57 BALLARD
SEATTLE , WA

Saratoga Capital , INC.
Recommendation Proposal Packet
December 7, 2020
1761 NW 57th St., Seattle, WA
98107
SDCI Number: 3034783-LU

RESPONSE TO EARLY DESIGN GUIDANCE

1.b

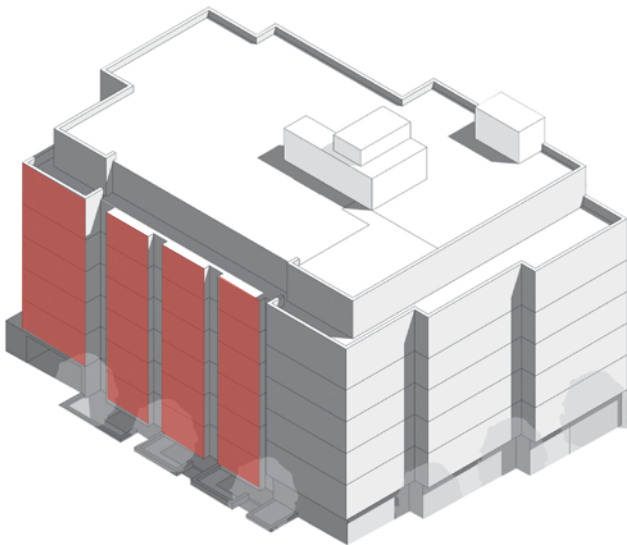
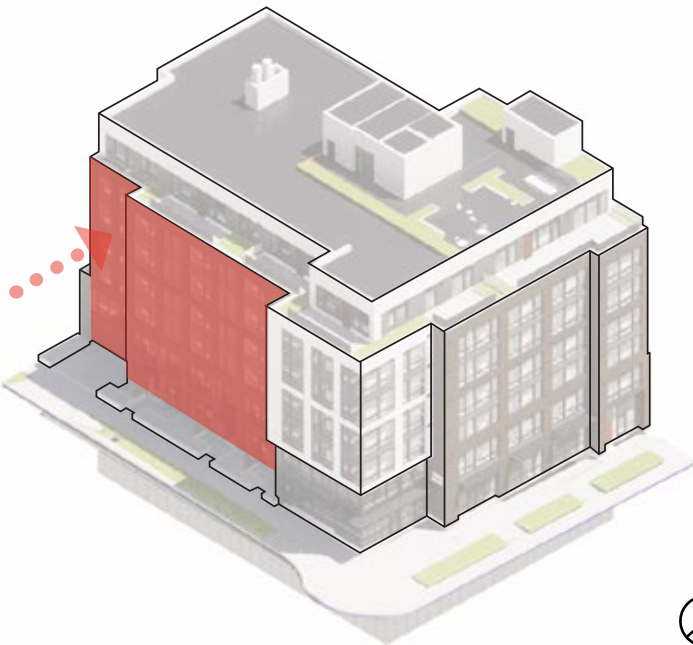
- b. The Board discussed the differing conditions of NW 57th Street versus 20th Avenue NW, which appear to be driving the massing decisions in the preferred scheme. While the Board acknowledged the importance of responding to context, they stressed that the two facades were too inconsistent and directed the applicant to simplify and unify the two facades using a single design language. The Board stated that the proposal’s corner location will result in the building being viewed as a whole. Unify the two facades into a cohesive whole while continuing to respond to the unique character and conditions present on each street. (CS2-C-1, CS2-1-b, CS3-A,DC2-A)

Applicant has redesigned the 57th street façade to unify the two facades. 57th façade will continue stepping back from the street in a similar manner to the façade on 20th. Stepping the façade back to the at the east property line provide an appropriate massing response to the adjacent building and provide a better transition to more residential scale of 57th street. Both facades will now be asymmetrical as opposed to the previous NW 57th façade which was more symmetrically defined by bookends.

[Please refer to Diagram 1.b]

1.c

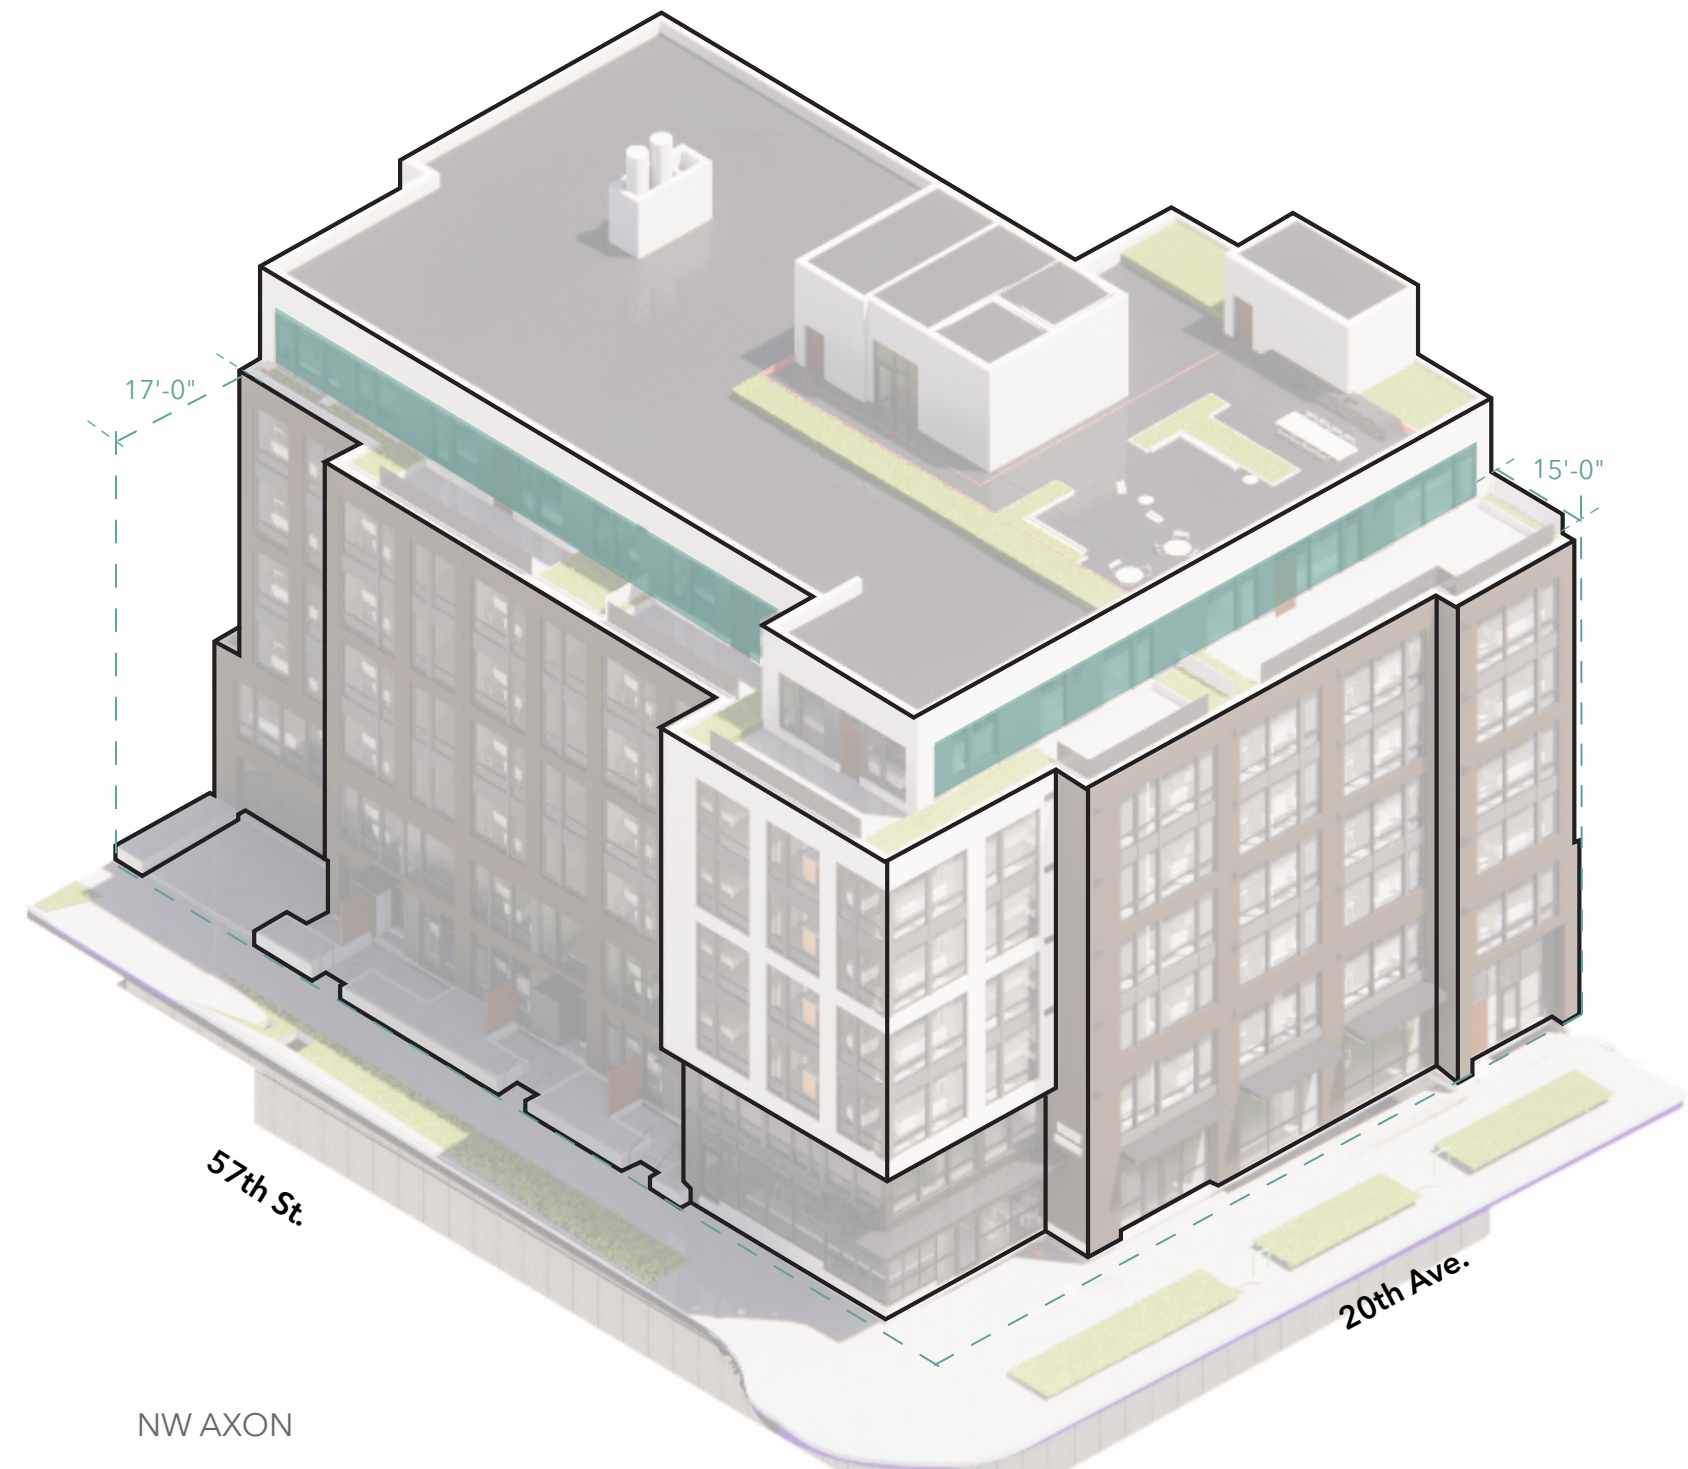
- c. The Board suggested that material choice and application can help unify the two facades. (CS3-A, DC2-A)

Both facades will be similarly composed of a two-story base with “cocoa” ceramic panel and intermediate bronze color metal panel spandrel to emphasize the double-stack bay. The middle portion of the building, levels 3-6, will be the same panel color/material with a double stacked window system to emphasize verticality. Level 7, which is recessed from the overall mass of the building along both facades, will be clad in a lighter color cement fiber board with darker metal panel infill color to match the intermediate floor spandrels below. **[Please refer to Diagram 1.c and see Section 7 for full details]**

2.a & 2.b

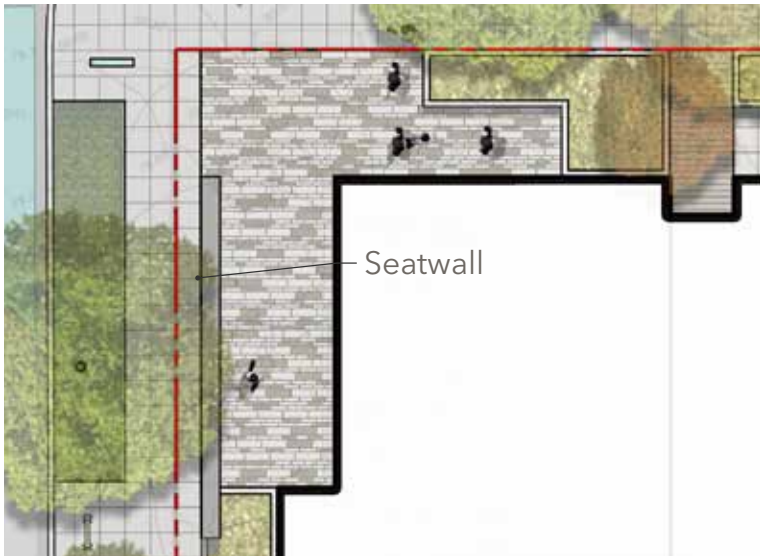
- a. The Board was particularly concerned about the location and viability of the proposed retail space. The Board stated that the retail space feels “shoehorned” and is not consistent with the site’s zoning designation (NC3P-75) and location within an urban village, which both place greater emphasis on street-level activation and engagement. The retail space is further compromised by the proposed location of an egress stair within the space. (PL3-C, PL3-4)

- b. The Board stated that the corner seemed to be the most logical and appropriate location for the retail space. The eroded mass and proposed seat wall provide a prime opportunity for street activation that a residential lobby is unlikely to achieve. (PL1-2-b, PL3-C, PL3-1-b)

Response: The applicant is proposing approximately 800 SF of space dedicated for potential retail for the project, more than double the previous submittal. The space is now located at the corner of 20th and 57th and is the most likely place for retail to succeed when considering lack of any adjacent retail synergy currently this far north of the retail core on Market street.

Response: Retail has been moved to corner location. The edge of the fully glazed transparent storefront has been pulled approximately 11’ inboard from the property line along 20th adjacent to the corner. Providing this will allow more open space for ancillary activities and active uses, a better transition from public to semi-private space and a softer street wall. The residential lobby entry will be moved away from the corner to a more central location along 20th.

2.c

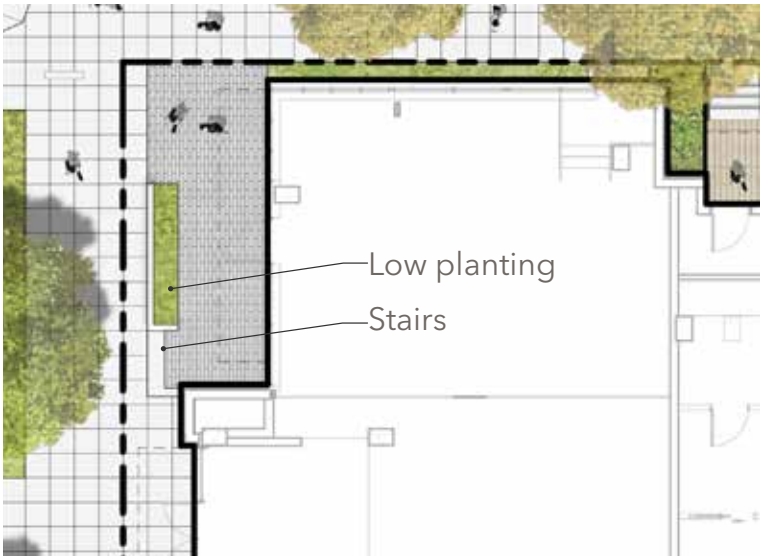
- c. The Board discussed the corner residential entry which they identified as a more appropriate location for retail uses. The Board was also concerned about the relationship between the residential entry and the proposed seat wall along 20th Avenue NW, which functions as a barrier, limiting the entry’s ability to make a strong connection to the street. (CS2-B-2, PL3-A-4)

Response: The seat wall has been replaced with a low planting wall and a set of stairs which will make up the grade difference on the sidewalk which will add more porosity to the open

space and provide a better connection to the street. Low plantings will be installed for greater visual connectivity and movable furniture could be utilized within this flexible open space.

DEPARTURE 2A: RESIDENTIAL USES AT STREET LEVEL

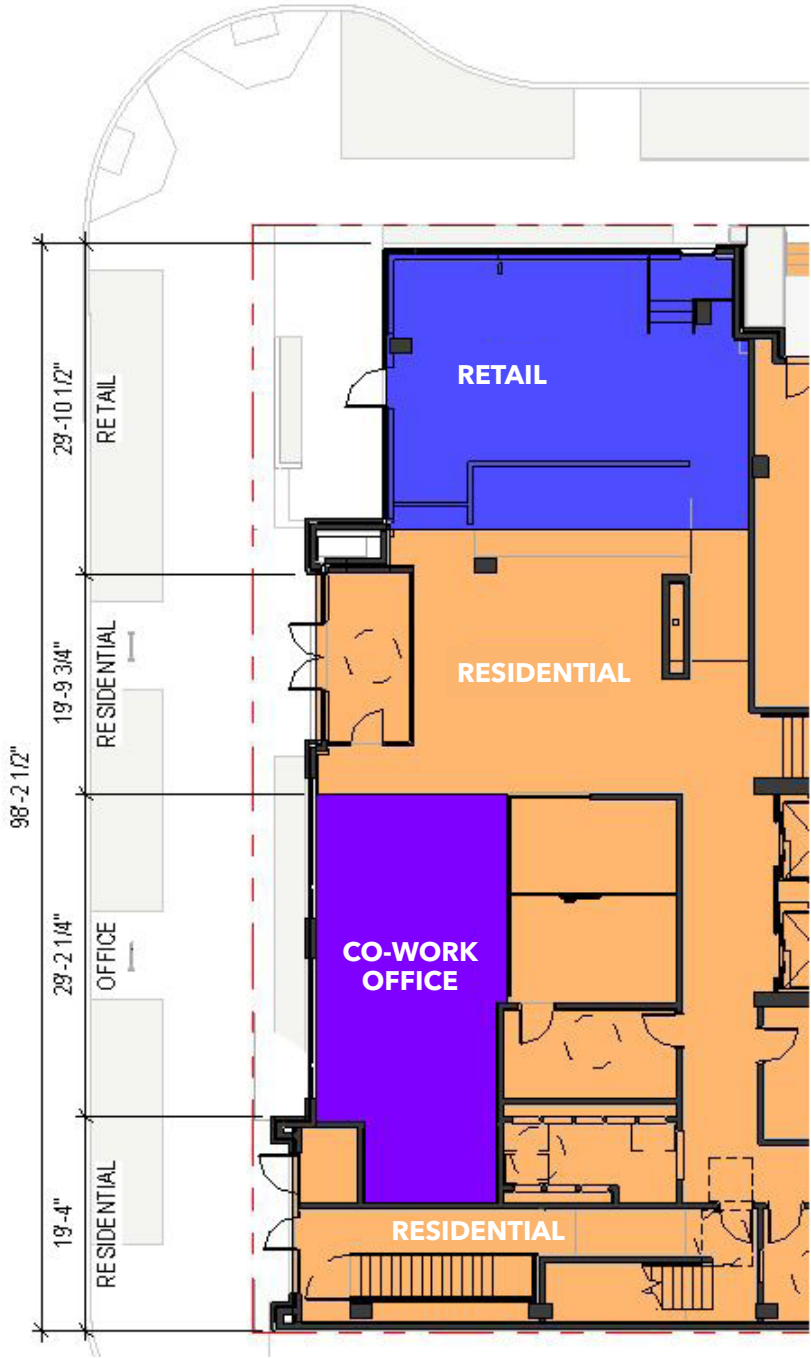
The Board raised several concerns about the location and viability of the retail space, the lack of activation in other street level uses, and the ability to activate and engage with the public realm. The Board did not see a compelling, design-based rationale to support the departure request as currently proposed but expressed an openness that some deviation from these standards may be appropriate if the result is a design that better meets the intent of the Design Guidelines.

The applicant is requesting to depart the no more than 20% of the street-level, street-facing facade be residential use. Proposed percentage of residential use will be 40%.

DEPARTURE 2B: NON-RESIDENTIAL USES AT STREET LEVEL

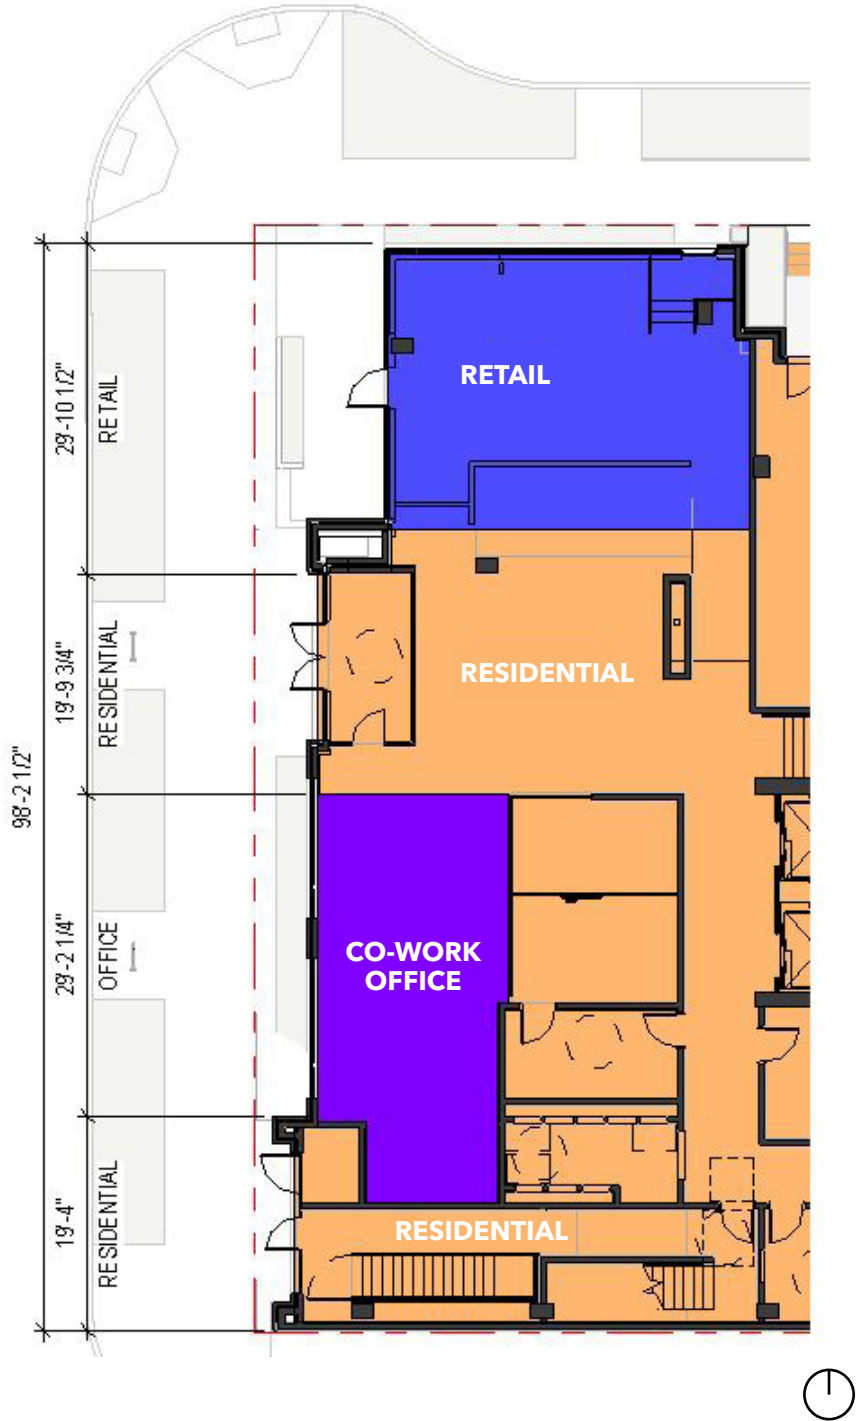
The Board raised several concerns about the location and viability of the retail space, the lack of activation in other street level uses, and the ability to activate and engage with the public realm. The Board did not see a compelling, design-based rationale to support the departure request as currently proposed but expressed an openness that some deviation from these standards may be appropriate if the result is a design that better meets the intent of the Design Guidelines.

The applicant is requesting to depart the requirement of 80% of the street-level, street-facing facade to be non-residential uses. Applicant is requesting 60% of the façade be non-residential use.
